Addendum No.: One

Date Of Addendum: January 7, 2019

CT DAS | Construction Services | Office of Legal Affairs, Policy, and Procurement
Bathroom renovations and ADA Upgrades
410 Capitol Avenue
Hartford, CT
BI – 2B – 400

4 DF GUARD PANEL
SKA-1 SCALE: 1/2" = 1'-0"

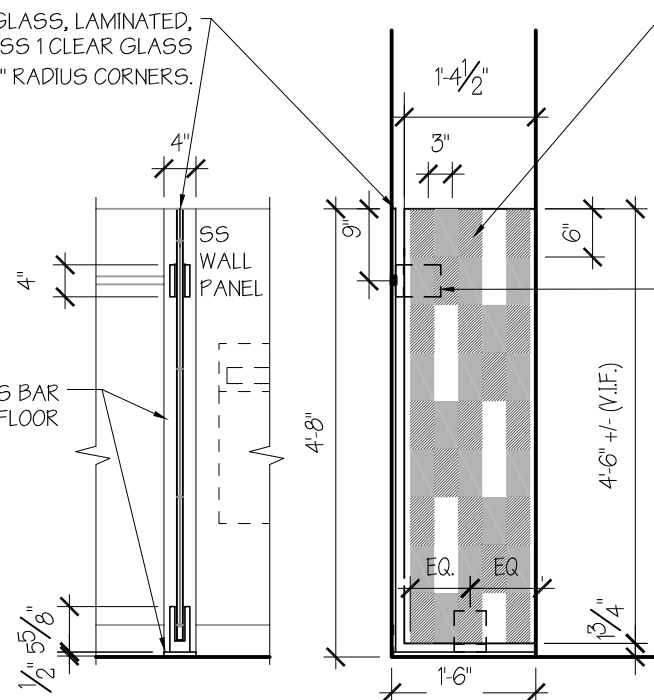
In Drawing A.2.01, Detail 10 DF GUARD PANEL:

Question: Is there a spec for the fritted glass panel next to the water cooler on the 1st floor?

SUBSTITUTE: 4/SKA-1

Answer: Provide ¾" thick, clear laminated tempered glass with polished edges and ½" radius corners. See 4/SKA-1.

3/4" THICK STRUCTURAL GLASS, LAMINATED, TEMPERED, CLASS 1 CLEAR GLASS WITH POLISHED EDGES, 1/2" RADIUS CORNERS.

4" x 1/2" SS BAR FASTENED TO WALL AND FLOOR

DECORATIVE PATTERN PRINTED ON TRANSPARENT ADHESIVE PVC FILM, MOUNTED TO GLASS ON EXTERIOR SIDE. FILE PROVIDED BY ARCHITECT.

1 PARTIAL DEMO PLAN (2ND, 3RD, 4TH FLOOR)

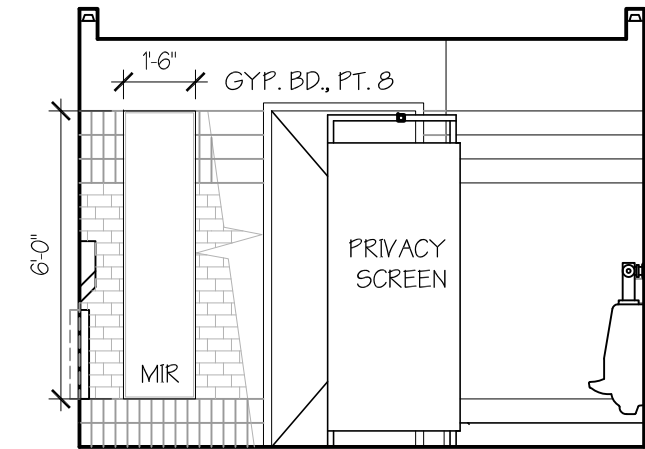
In Drawings A.1.00, A.1.01:

ADD: Cut new doors in the existing walls at Corridor East on 2nd, 3rd and 4th floors, for access to sprinkler valves in Janitor's Closets.

See 1/SKA-1, 2/SKA-1.

CUT WALL FOR NEW 3' x 7' DOOR. REFER ALSO TO NOTE 10/A1.00.

5 MEN'S ROOM ELEVATION
SKA-1 SCALE: 1/4" = 1'-0"

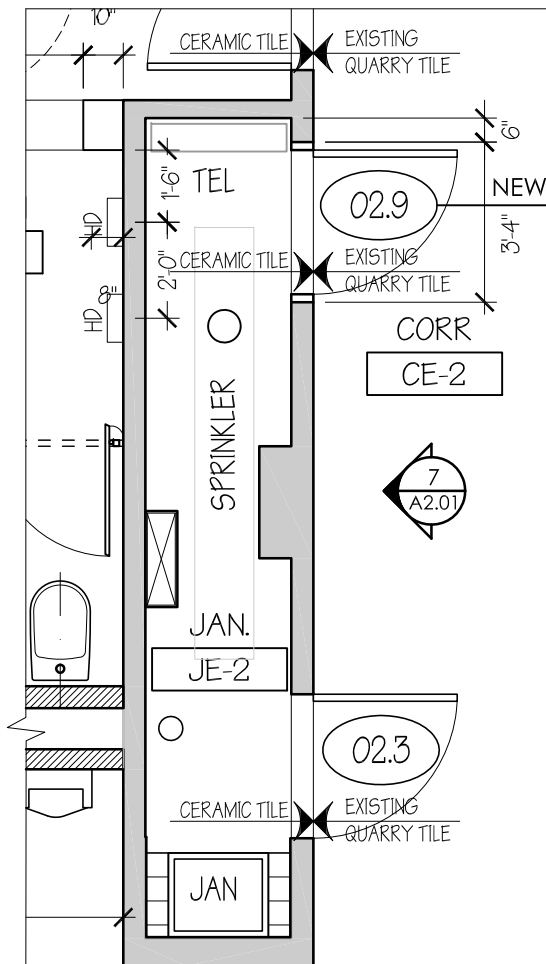
In Drawing A.2.01, Detail 3.4 MEN'S ROOM WEST WALL:

Question: In the men's rooms, Specification 102800 3.05 and floor plans show/indicate 3 mirrors in each room. However the elevations only show 2 mirrors. Please advise which is correct. If there are to be 3 please provide size for 3rd one.

SUBSTITUTE: 5/SKA-1

Answer: 1'6" wide by 6' tall mirror, installed by the entry door, see location in plan 1/A1.01 and elevation 4/SKA-1.

3 DOOR SCHEDULE
SKA-1

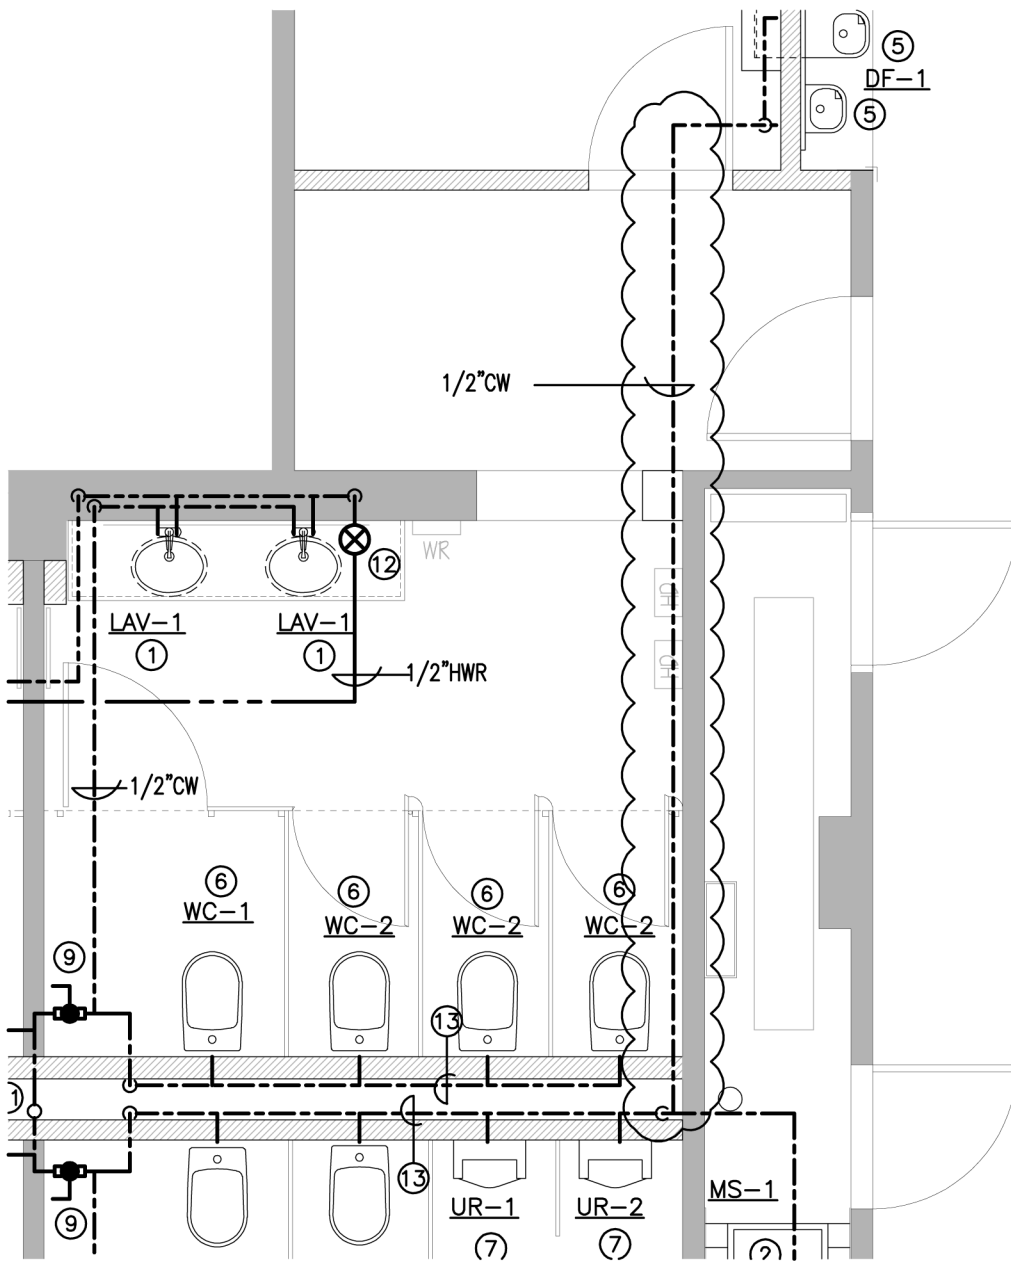
In Drawing A.3.01, DOOR SCHEDULE:

Question: On the door schedule door 1.5 calls out for the frame as existing. It is a new drywall. Are we using one of the removed frames or providing a new frame?

SUBSTITUTE: 3/SKA-1

Answer: Provide new frame. See 3/SKA-1 for Door Schedule.

ROOM NAME & NUMBER	DOOR						FRAME						REMARKS		
	DR #	SIZE	MAT	TYPE	FINISH	LABEL	MAT	TYPE	FINISH	LABEL	JAMB	HEAD		SILL THRESH	HDW SET#
ALL FLOORS															
ME-1, 2, 3, 4	1.1-4.1	3'-0"X7'-0" *	HM	A	PT. 9	-	HM	EXIST	PT. 10	-	-	-	CT	4	PATCH FRAME AT REMOVED AUTOMATIC DOOR CLOSER
MW-1, 2, 3, 4	1.2-4.2	3'-0"X7'-0" *	HM	A	PT. 9	-	HM	EXIST	PT. 10	-	-	-	CT	4	REPAIR/PATCH FRAME
JE-1, 2, 3, 4	1.3-4.3	3'-0"X7'-0" *	HM	A	PT. 9	-	HM	EXIST	PT. 10	-	-	-	CT	2	REPAIR/PATCH FRAME
JW-1, 2, 3, 4	1.4-4.4	3'-0"X7'-0" *	HM	A	PT. 9	-	HM	EXIST	PT. 10	-	-	-	CT	2	REPAIR/PATCH FRAME
WE-2, 3, 4	2.5-4.5	3'-0"X7'-0" *	HM	A	PT. 9	-	HM	EXIST	PT. 10	-	-	-	CT	4	REPAIR/PATCH FRAME
WW-1, 2, 3, 4	1.6-4.6	3'-0"X7'-0" *	HM	A	PT. 9	-	HM	EXIST	PT. 10	-	-	-	CT	4	REPAIR/PATCH FRAME
BABY-1	1.7	3'-0"X7'-0" *	HM	A	PT. 9	-	HM	HM-1	PT. 10	-	J-1	H-1	CT	1	
STOR-2, 3, 4	2.7-4.7	3'-0"X7'-0" *	HM	A	PT. 9	-	HM	HM-1	PT. 10	-	J-1	H-1	CT	3	
LACT-1, 2, 3, 4	1.8-4.8	3'-0"X7'-0" *	WOOD	A'	CLEAR	-	HM	HM-1	PT. 10	-	J-1	H-2	CT	1

JE-2, 3, 4	2.9-4.9	3'-0"X7'-0" *	HM	A	PT. 9	-	HM	HM-1	PT. 10	-	J-1	H-2	CT	2	PROTECT FLOOR QUARRY TILE AT CORRIDOR DURING WALL DEMOLITION.
WE-1	1.5	3'-0"X7'-0" *	HM	A	PT. 9	-	HM	HM-1	PT. 10	-	J-1	H-2	CT	4*	*REPLACE CONT. HINGE W/ 3 (HEAVY WEIGHT) T4A3386 4-1/2" x 4-1/2" U832D MK

SKP-1

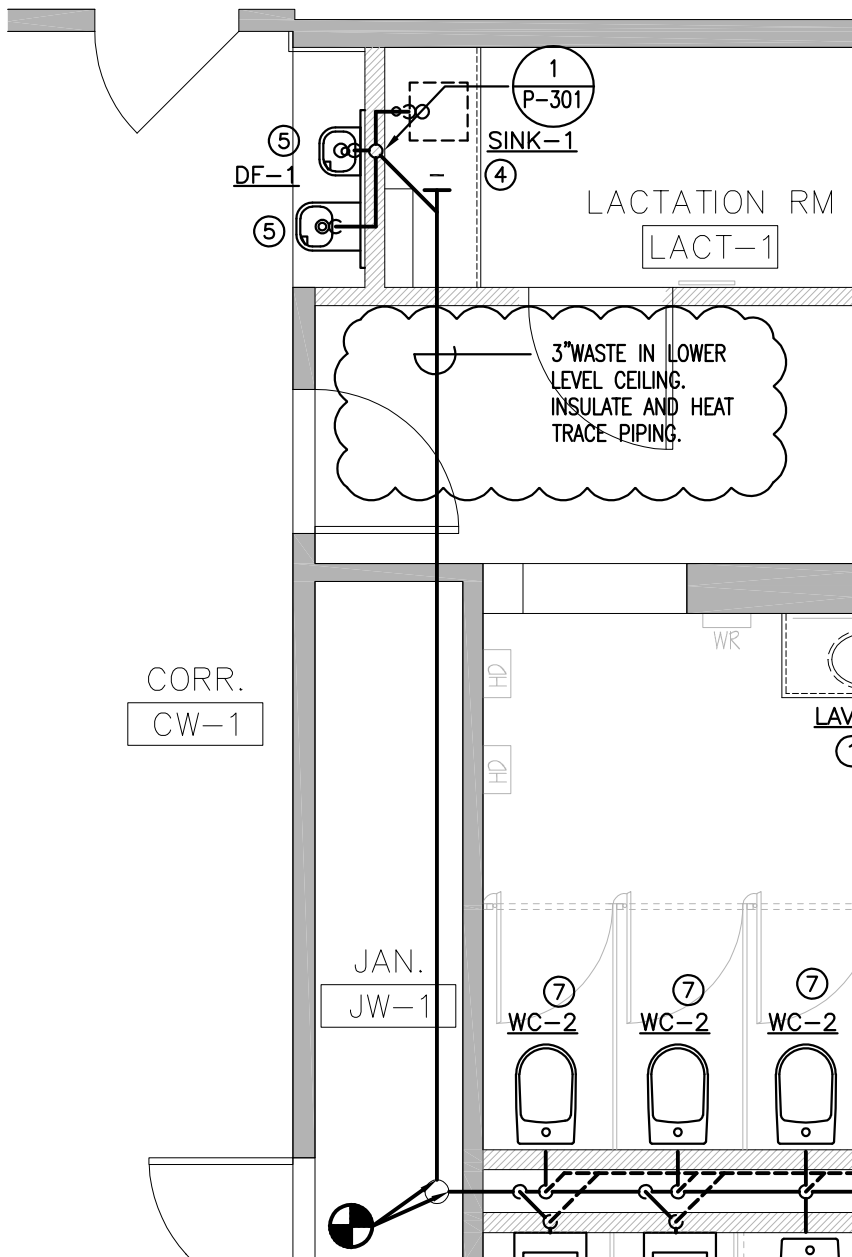
In Drawing P2.01:

ADD: Route new water piping through bathrooms to avoid additional ceiling demo work. See SKP-1.

LOCATE CW TO DF-1 ABOVE RESTROOM CEILING.
